SERVICE DIRECTIVE BULLETIN

SERVICE NOTE NO. 0026

Subject: Cooling Air Turning Vane - P/N 280-126001-9

Model: 280 - Serial Numbers 1002, 1003, 1004, 1005, 1006, 1007, 1008, 1009, 1010, 1011, 1012, 1014, 1015

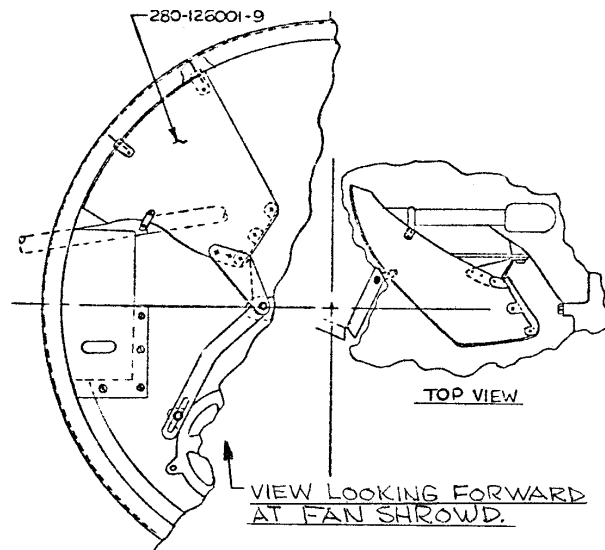
We have had a report from field service of one instance where the cooling air turning vane attachment failed. Separation of this attachment will allow the turning vane to shift and possibly come in contact with the cooling fan. The location of the turning vane P/N 280-12~001-9 is shown in the illustration below:

Immediate visual inspection of the turning vane P/N 280-126001-9 should be accomplished. This inspection is to be repeated at 5-hour intervals thereafter. Access for inspection can be made through upper left engine cooling shroud panel. It is further recommended that a new turning vane (P/N 280 -126001 -9, Rev. A) be installed to eliminate this inspection requirement. This component is available through Enstrom Customer Service.
